Bulletin No.: PI0807A

# PRELIMINARY INFORMATION

**Subject: Exhaust Rattle Noise**

Models: 2011-2012 Chevrolet Camaro Convertible

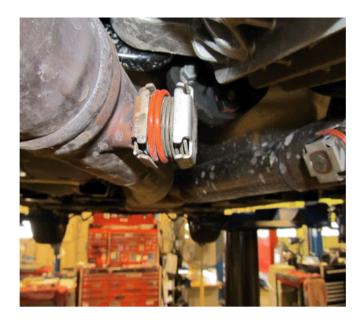
Some customers may comment on an exhaust rattle or noise when at idle or slow vehicle speeds up to 1300 engine rpm.

The spring in the exhaust valve may be causing the exhaust to rattle or make noise.

Technicians should follow the procedure below and install two silicone O-rings over each of the exhaust valve springs to dampen the rattle.

- 1. Raise the vehicle.
- 2. Install two O-rings onto the left exhaust valve spring.
- 3. Install two O-rings onto the right exhaust valve spring.
- 4. Lower the vehicle.
